Zoning Code Amendment Language
(Annotated)

***Title 21 Text Amendment to Off-Street Parking and
Site Access Regulations***

PZC Case No. 2022-0026

***Anchorage 2040 Land Use Plan
Implementation Actions 4-3 and 4-6***

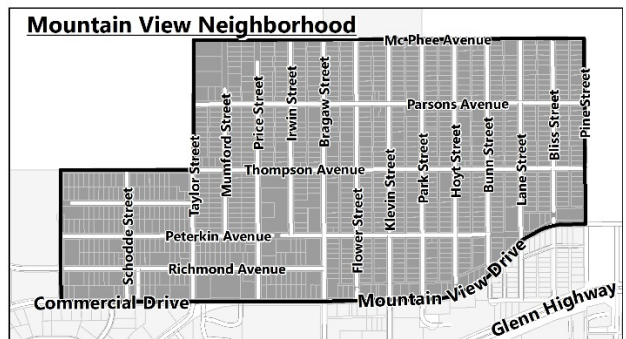
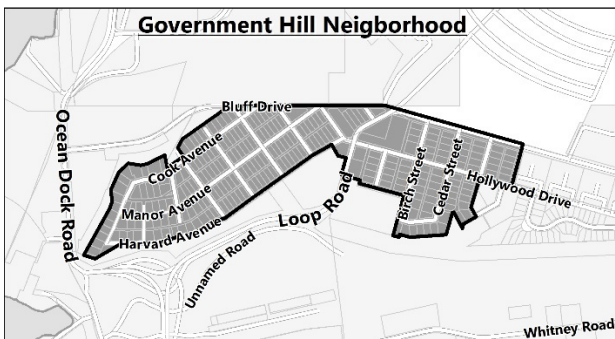
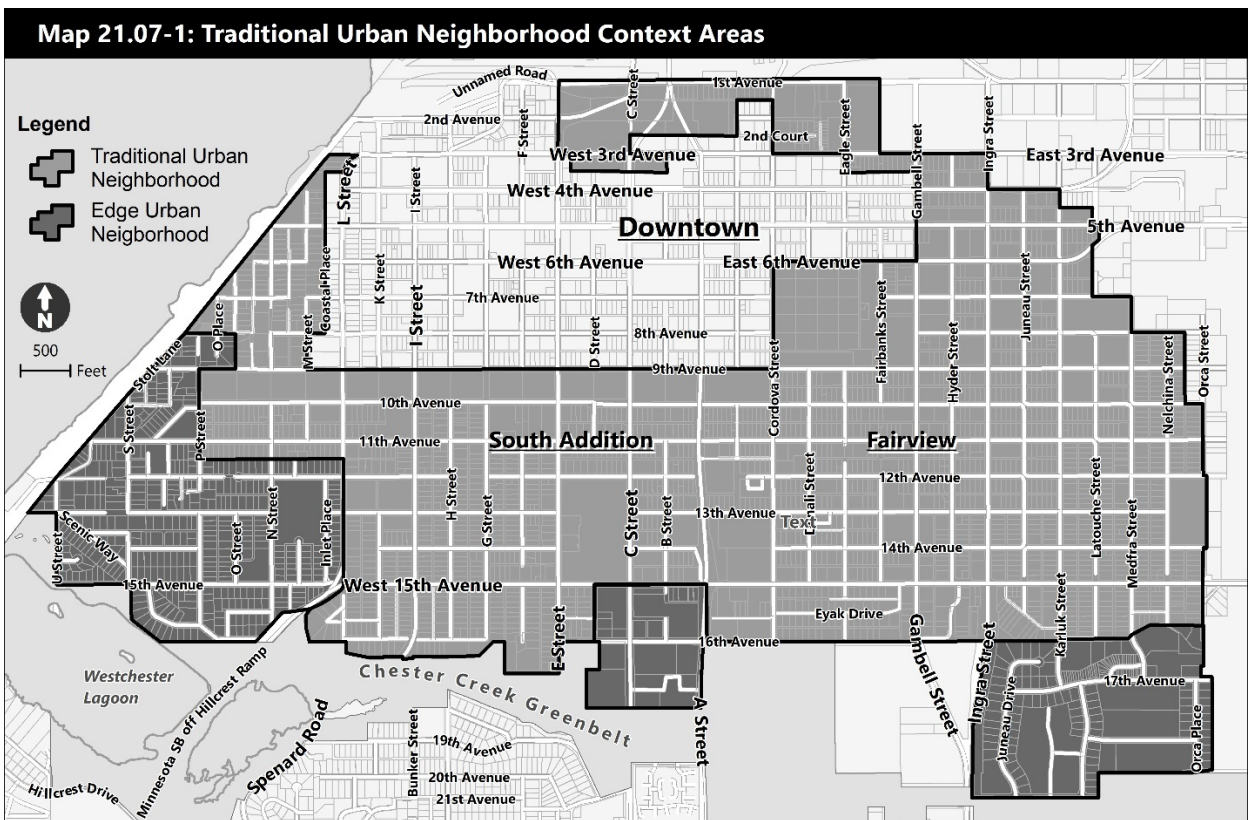
This page inserts the first of several maps of Neighborhood Development Context boundaries into Title 21 Section 21.07.015. The maps provide enough detail and landmarks for applicants to determine the location of their properties relative to the boundaries of the Neighborhood Development Context Areas.

<i>Line (s) #</i>	<i>Comment on Change</i>
Map	<p>Map 21.07-1: Traditional Urban Neighborhood Context</p> <p>This map shows the Traditional Urban Neighborhood Contexts, including Fairview and South Addition, and inset maps indicating the portions of Government Hill and Mountain View neighborhoods that are in the Traditional Urban Neighborhood Contexts.</p> <p>The Downtown (DT) zoning districts are not included as they are addressed in Chapter 21.11, Downtown.</p> <p>Map 21.07-1 and its insets also show several Edge Urban Neighborhood Contexts in this part of town. These include portions of western and southern South Addition and southeastern Fairview.</p>

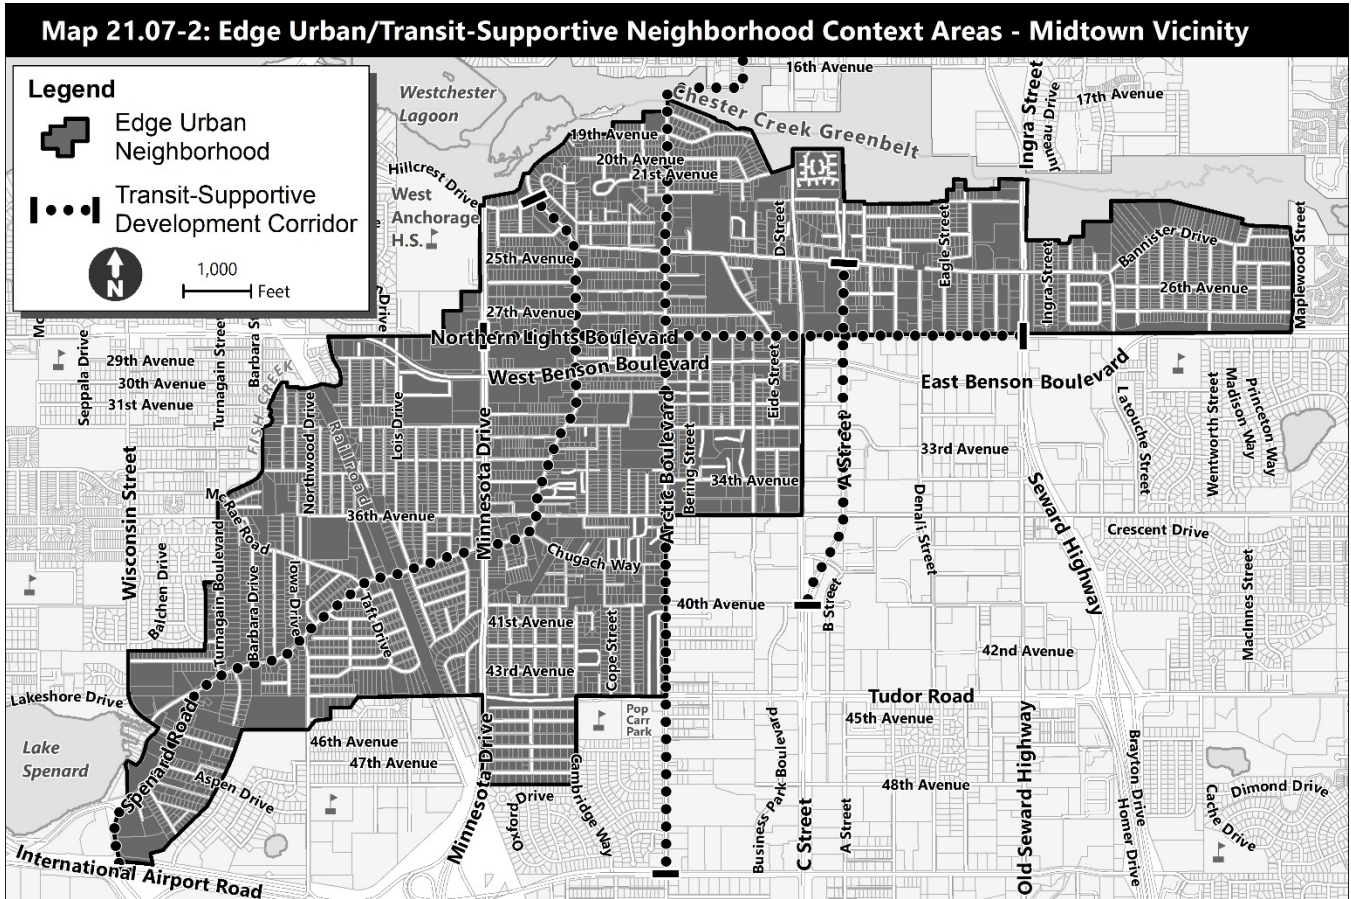
This page inserts one of several maps of Neighborhood Development Context Area boundaries into Title 21 Section 21.07.015. The maps provide enough detail and landmarks for applicants to determine the location of their properties relative to the boundaries of the Neighborhood Development Context Areas.

These maps indicate where the area-specific parking requirements established in 21.07.090E.2. (page 27) apply.

<i>Line (s) #</i>	<i>Comment on Change</i>
Map	<p>Map 21.07-2: Edge Urban / Transit-Supportive Neighborhood Context in Midtown</p> <p>Delineates the boundaries of the Edge Urban Neighborhood Contexts in and around Midtown and Spenard, relative to streets and property boundaries.</p> <p>It also shows the centerlines of the Transit-Supportive Development Corridors (TSDCs) in Midtown and Spenard. The centerlines run on the centerlines of street rights-of-way. End points shown as dashes indicate end points at center points of street ROW intersections.</p> <p>As provided in the introduction to this subsection 21.07.015D, on page 7 lines 8-12, all properties within ¼ mile of these line segments are considered to be within the TSDC, and eligible for the lower, area-specific parking requirement for TSDCs on page 27.</p>

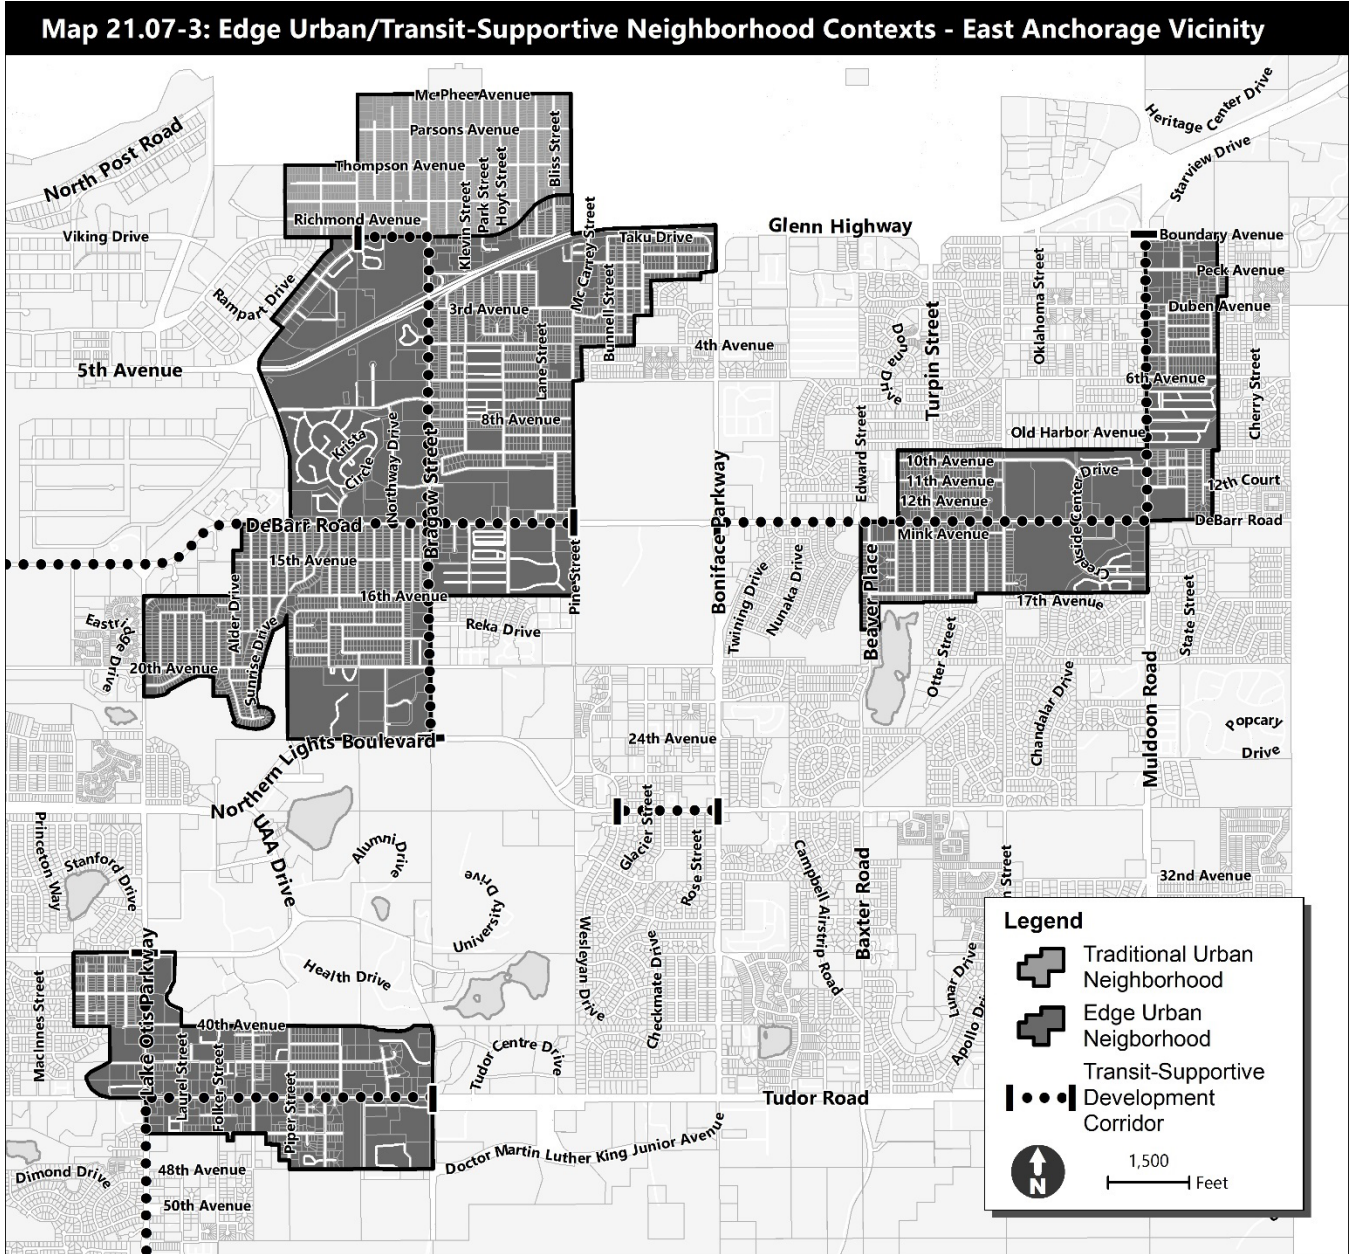
This page inserts one of several maps of Neighborhood Development Context Area boundaries into Title 21 Section 21.07.015. The maps provide enough detail and landmarks for applicants to determine the location of their properties relative to the boundaries of the Neighborhood Development Context Areas.

<i>Line (s) #</i>	<i>Comment on Change</i>
Map	<p>Map 21.07-3: Edge Urban / Transit-Supportive Neighborhood Context in East Anchorage</p> <p>Delineates the boundaries of the Edge Urban Neighborhood Contexts in and around DeBarr, Muldoon, and Lake Otis and Tudor, relative to streets and property boundaries.</p> <p>It also shows the centerline of the Transit-Supportive Development Corridors (TSDCs) in Northeast Anchorage, Airport Heights, peripheral parts of Mountain View, and in the University Area vicinity. The centerlines of TSDCs run on the centerlines of street rights-of-way. End points shown as dashes indicate end points at center points of street ROW intersections.</p> <p>As provided in the introduction to this subsection 21.07.015D., on page 7 lines 8-12, all properties within ¼ mile of these line segments are considered to be within the TSDC, and eligible for the lower, area-specific parking requirement for TSDCs on page 27.</p>

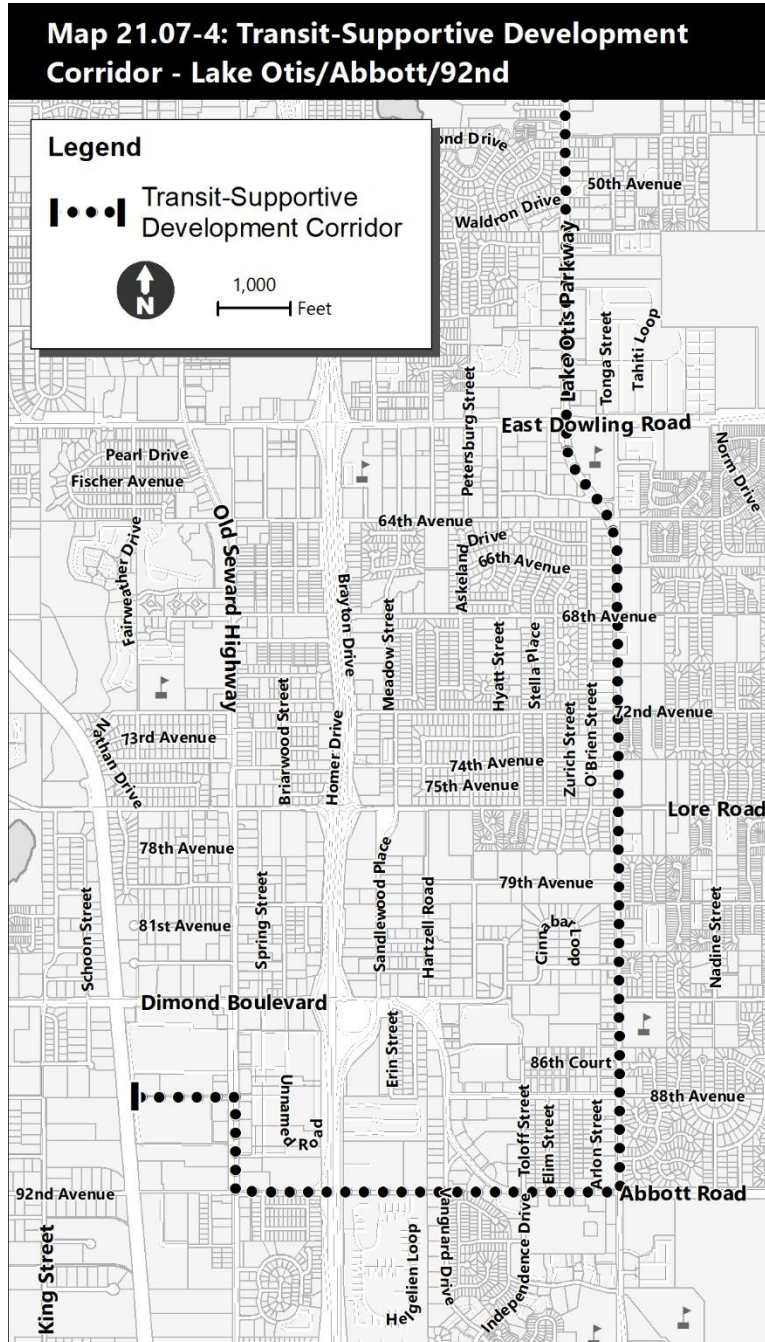
This page inserts the last of several maps of Neighborhood Development Context Area boundaries into Title 21 Section 21.07.015. The maps provide enough detail and landmarks for applicants to determine the location of their properties relative to the boundaries of the Neighborhood Development Context Areas.

These maps indicate where the area-specific parking requirements established in 21.07.090E.2. (page 27) apply.

<i>Line (s) #</i>	<i>Comment on Change</i>
Map	<p>Map 21.07-4: Transit-Supportive Development Corridor – Lake Otis/Abbott/92nd</p> <p>Delineates transit-supportive development corridor along Lake Otis/Abbott Road/92nd Street.</p> <p>As provided in the introduction to this subsection 21.07.015D., on page 7 lines 8-12, all properties within ¼ mile of these line segments are considered to be within the TSDC, and eligible for the lower, area-specific parking requirement for TSDCs on page 27.</p> <p><i>Discussion:</i> This corridor was adopted as part of the <i>2040 Land Use Plan</i> and is considered to have significant potential future additional opportunities for infill housing and further implementation of frequent bus service. The centerlines of TSDC run on the centerlines of street rights-of-way or at certain points on property boundaries.</p>

Section 21.07.060E.4., Standards for Pedestrian Facilities – On-site Walkways

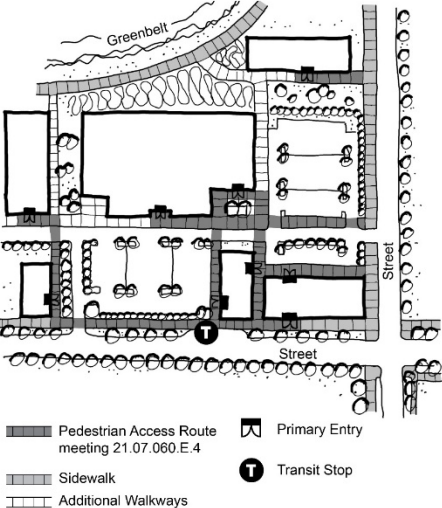
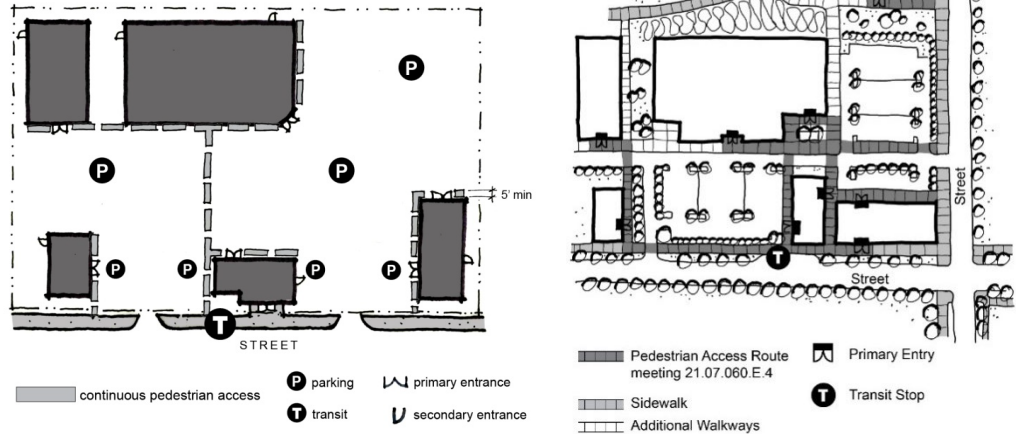
Line (s) #	Comment on Change
11-16	<p>Enhance existing illustration of continuous pedestrian access. The illustration at right is an enlarged version of the proposed replacement illustration on the next page.</p> <p>Illustrations are not regulatory but rather help convey the intent of the regulations (21.15.010, Rules of Interpretation). This clarifies existing standards.</p> 
18-20	<p>Consolidate residential walkway requirements and alternative pedestrian access options from Section 21.07.110 Residential Design Standards. This merges and standardizes existing on-site pedestrian connection requirements for residential uses from sections 21.07.110C.5. (page 68 lines 22-32) and D.3.c. (page 72 lines 38-40), which are proposed to be deleted from those sections.</p>
22-28	<p>Consolidate and clarify on-site walkway width and design requirements. The walkway width and improvements standards are consolidated into this subsection c. The redundant, identical standards for walkway width and improvements are deleted from subsection 21.07.060F.3. (see page 16, lines 26-37).</p> <p>Exclusion of vehicle overhang from the minimum unobstructed sidewalk width is deleted from this subsection because vehicle overhang into sidewalks is addressed in the off-street parking section of Title 21 and is unnecessary to repeat here.</p>

14 *(Replace existing illustration on the left with*
15 *illustration on the right.)*

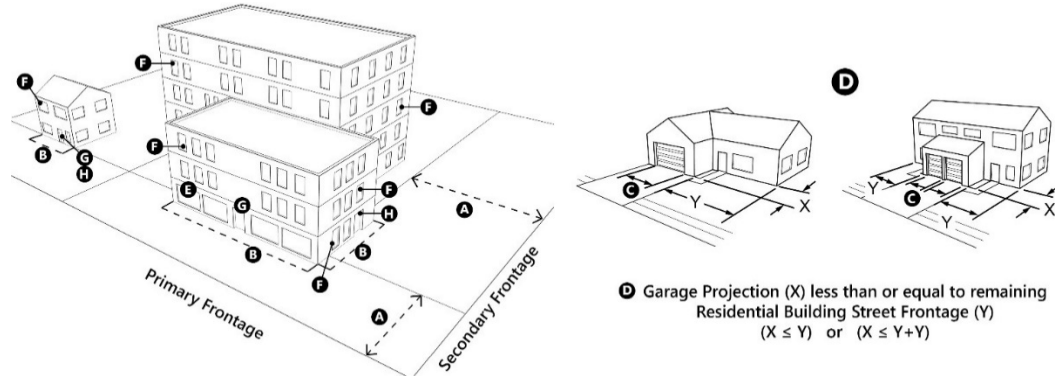
<i>Line (s) #</i>	<i>Comment on Change</i>
Table 21.07-2	Reformat pedestrian frontage standards from other parts of Title 21 into an illustration and table. The illustration visualizes the standards in the table. Each row in the table is a development standard and begins with a capital letter. The letter labels in the illustration correspond to the capital letters in the table. The table carries forward and clarifies how other parts of Title 21 have applied frontage standards to two street frontages, with the stronger standard on the primary frontage.
Table, parts A and B	Set a maximum front setback and a percentage of the building façade that must comply with the maximum front setback. Maximum setbacks are moved from Title 21 district-specific standards in 21.04.030 (pages 2-3) and also translated from parking facility criteria for parking reductions in 21.07.090F. (page 38 lines 8-13). They are made generally applicable in Urban Neighborhood Contexts. They are more relaxed on the secondary frontage and in the Edge Urban Neighborhoods. The maximum setbacks are based on prevailing building patterns and prioritization of pedestrian access in urban contexts. Although some U.S. cities do not allow any setback from the right-of-way in traditional urban contexts, allowing setbacks of up to 30 feet responds to Anchorage’s winter climate, streets, and development. 90 feet allows for a parking lot bay plus landscaping and walkways in front of a building.

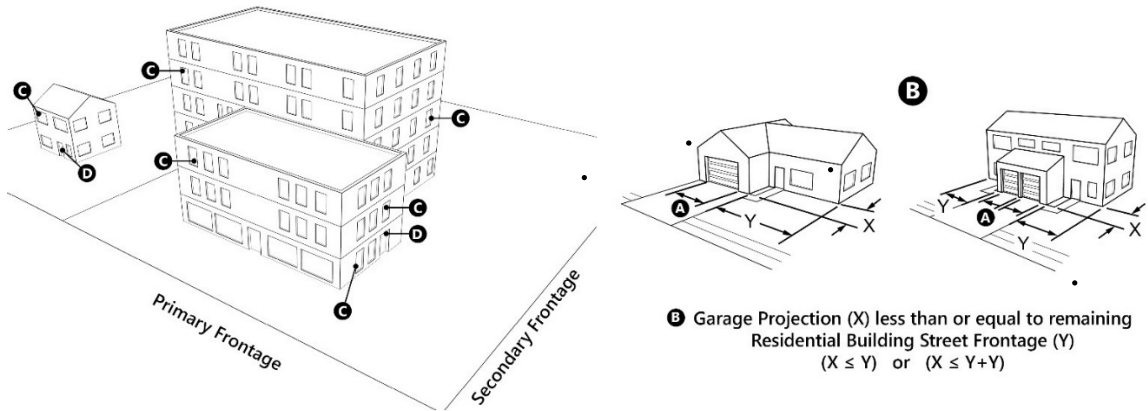
<i>Line (s) #</i>	<i>Comment on Change</i>
Table 21.07-3	Reformat pedestrian frontage standards from other parts of Title 21 into a table format. Each row in the table is a development standard and begins with a capital letter. The table brings forward and clarifies the current approach in other parts of Title 21 of applying frontage standards to no more than two frontages and applying the stronger standard only to the primary frontage.
Table Items A and B	Consolidate current limitations on residential garage width and projections. Table item A. consolidates the current 67% limitation on garages for residences in 21.07.110D.4.b. (page 73, line 12) and multifamily/townhouse building orientation choices 21.07.110C.6.e., f., g., and h. (pages 69-70). It relaxes the maximum allowed percentage of the façade width from 67% to 75% on secondary frontages. Table item B brings forward the residential garage standard in 21.07.110D.4. (page 73 lines 7-11) for single-family and two-family buildings, and corresponds to building orientation menu choices 21.07.110C.6.e., f., g., and h. (pages 69-70) for townhouse and multifamily buildings.

**Section 21.07.060F.17., Enhanced Sidewalk Option
(Re-named to Section 21.07.060G.19., Enhanced Street Sidewalk)**

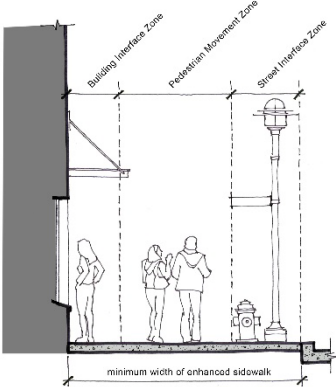
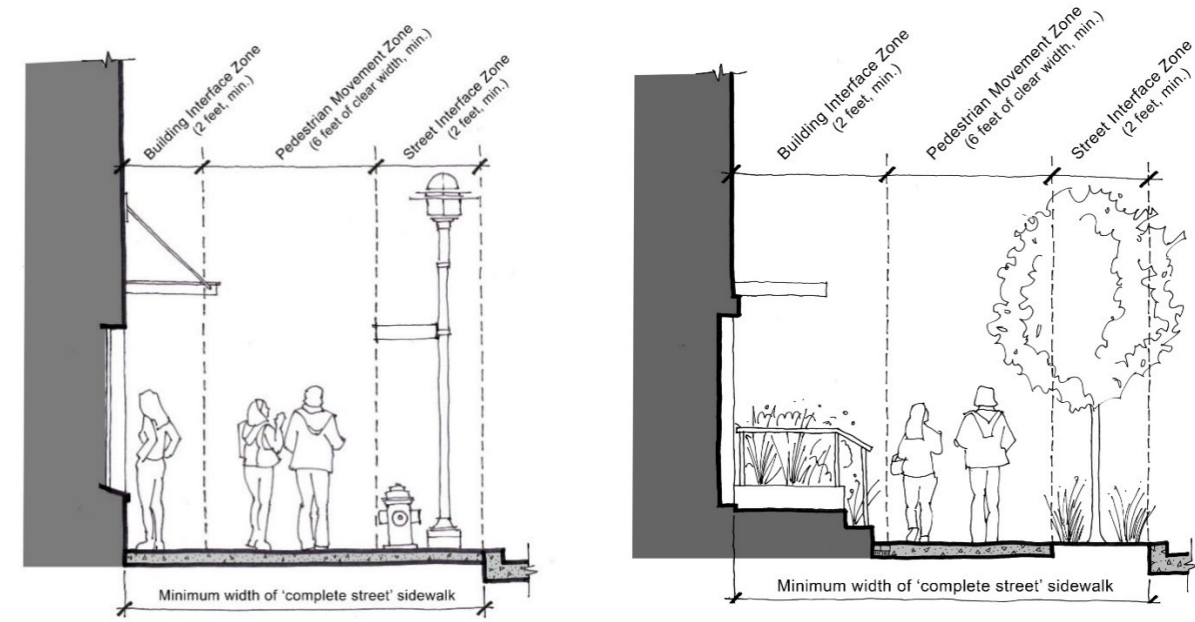
23-24	<p>Clarify existing commercial main street sidewalk illustration and add a second, residential sidewalk illustration.</p> <p>The existing commercial sidewalk illustration to be revised appears below. Width dimensions are proposed to be added to each of the three zones in the sidewalk cross section. A residential sidewalk version is proposed to be added to help code users visualize how the building interface zone and street interface zone would be in a residential setting.</p>
